TO: Wally Dubyk, Transportation Project Manager – Transportation Approvals
FROM: Adam Howell, P.Eng.
SUBJECT: 272-274 Parkdale Avenue – Screening Form Explanation
DATE: March 15, 2023

CIRCULATION COMMENT RESPONSE

COMMENT AND RESPONSE LOG

272-274 PARKDALE - COMMUNITY GARDENS

TITLE: LANDSCAPE SITE PLAN

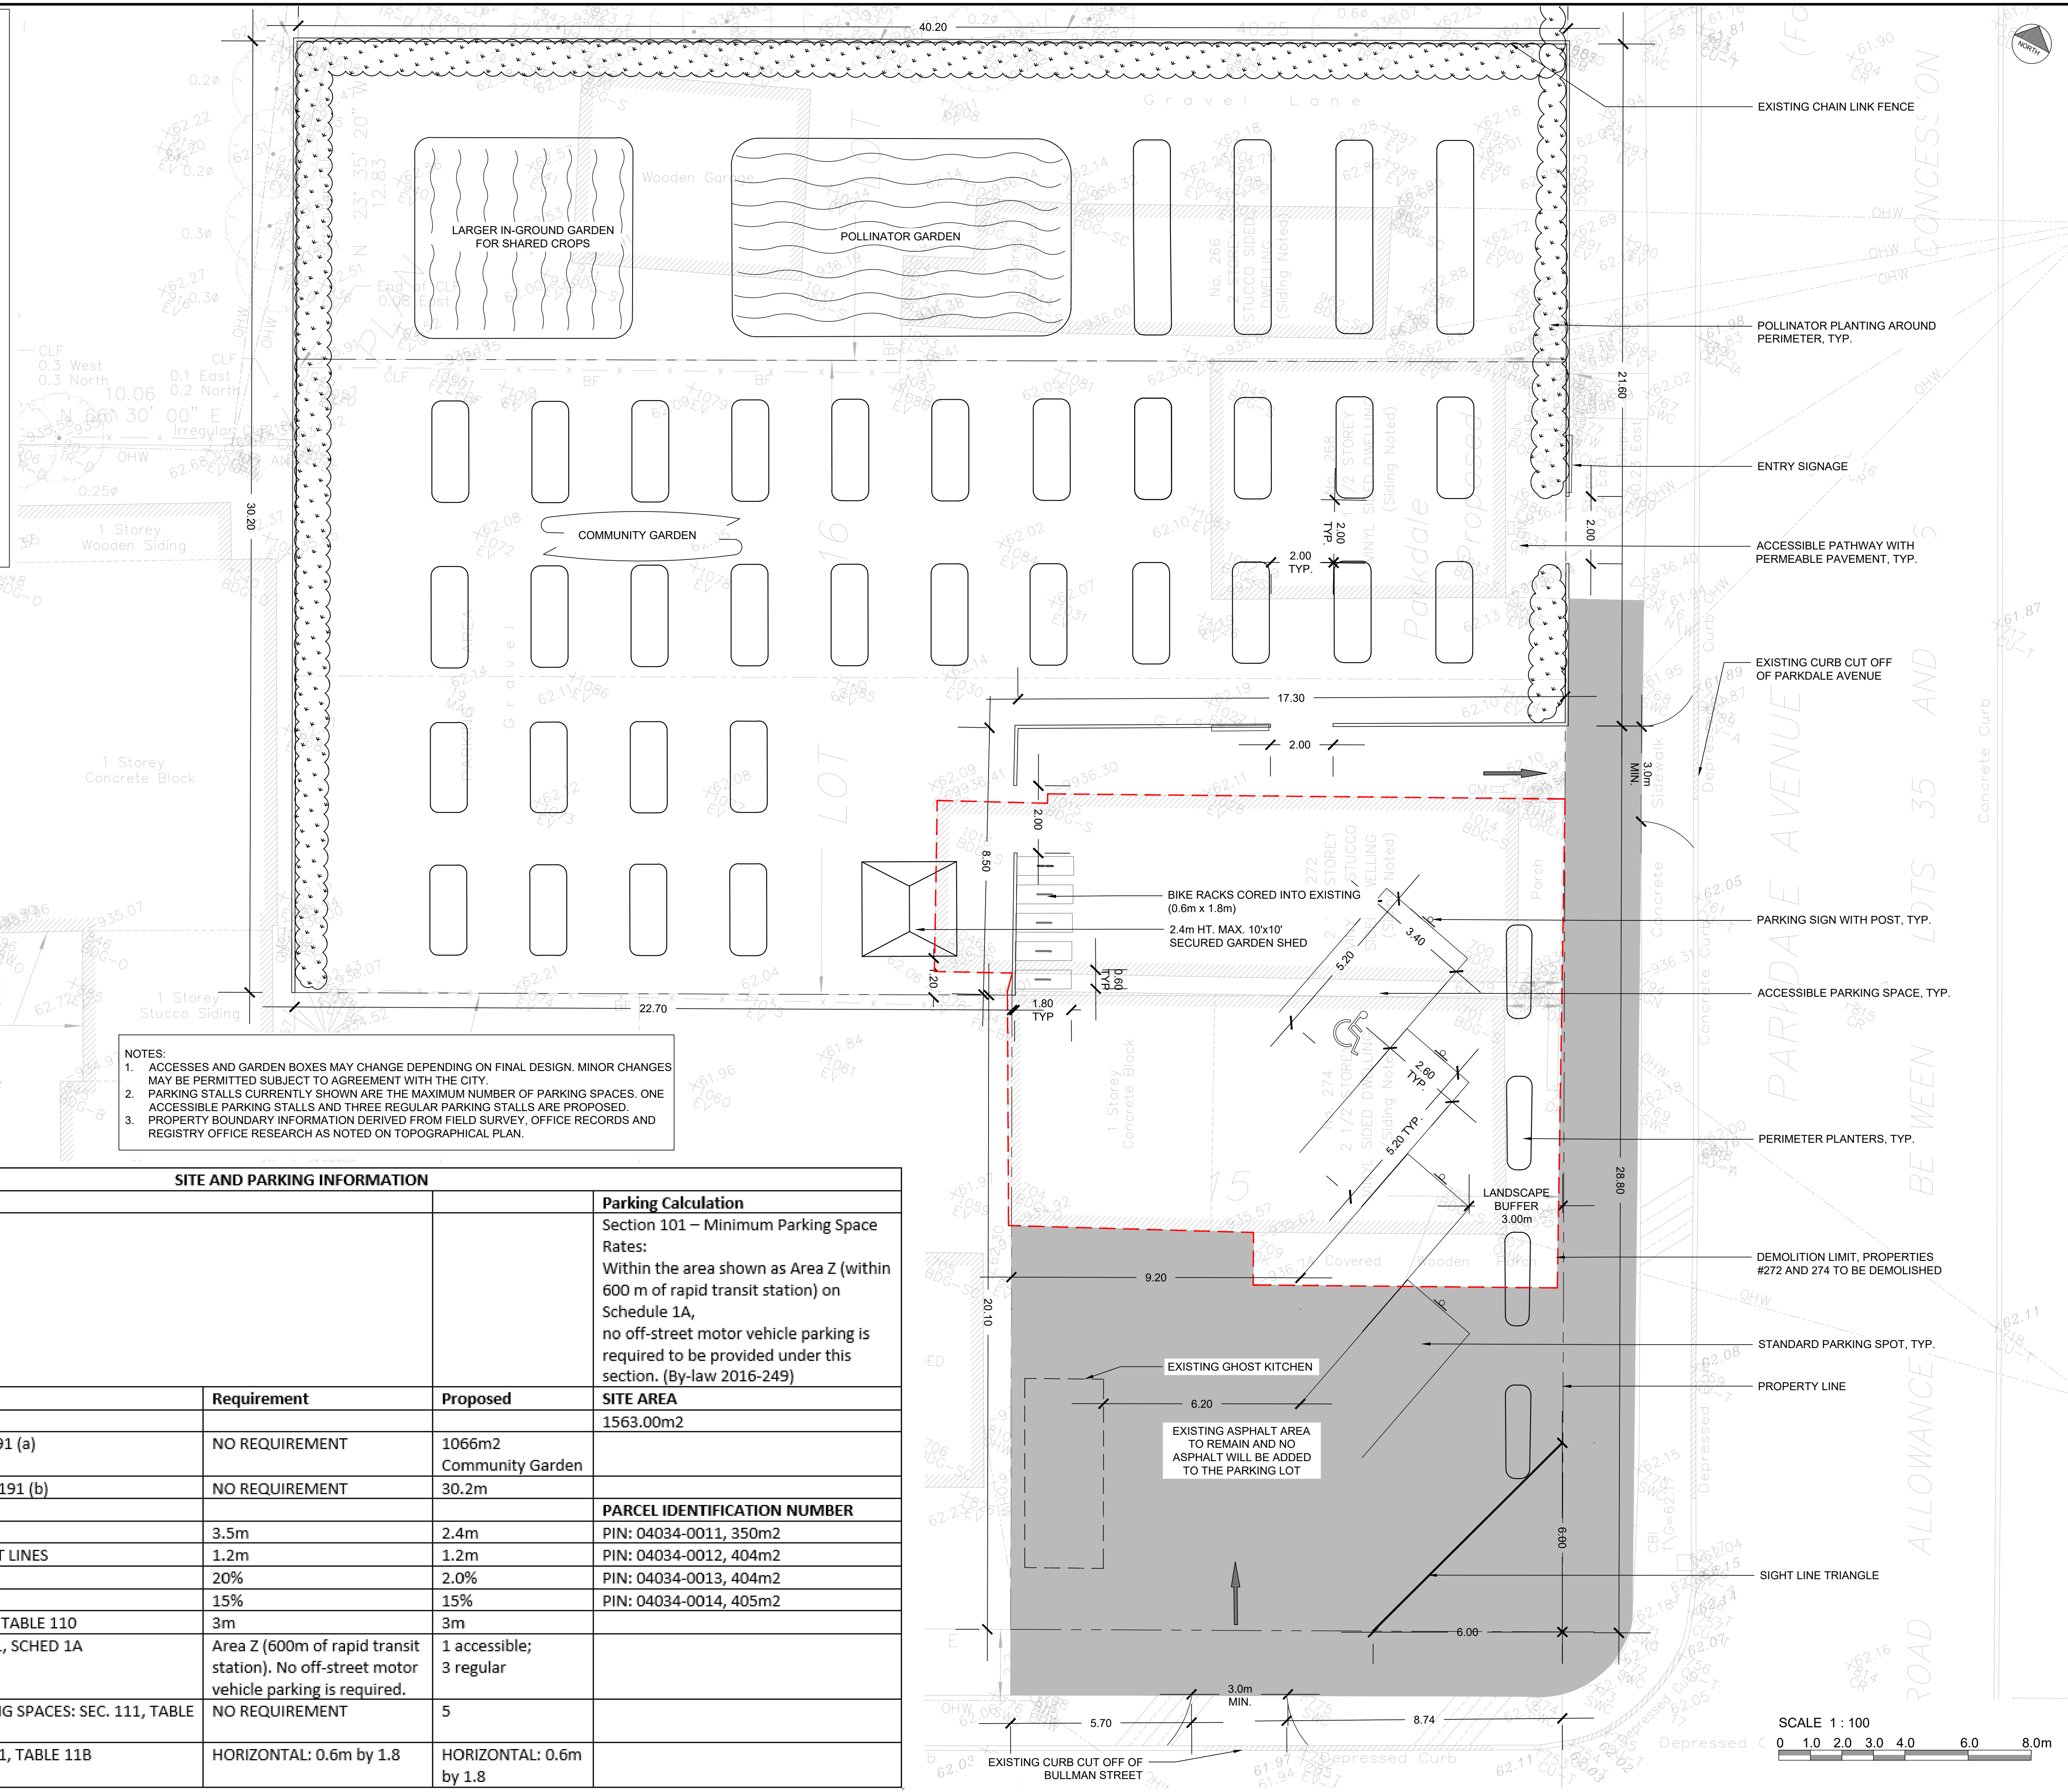
Thank you, no conveyance is being provided with this application.
- 4 The City of Ottawa Zoning By-Law Corner Sight Triangles (Sec. 57) states that no obstruction to the vision of motor vehicle operators higher than 0.75 metres above grade. The consultant should review the sight distance to ensure that no obstructions hinder the view of the driver at the Parkdale Avenue and Bullman Street intersection.

The Corner Sight Triangle has been added to the site plan in Appendix C. There are no obstructions for drivers on Parkdale Avenue and Bullman Street.
- 5 Permanent structures such as curbing, stairs, retaining walls, parking spaces and bicycle parking racks are not to extend into the City’s right-of-way limits.
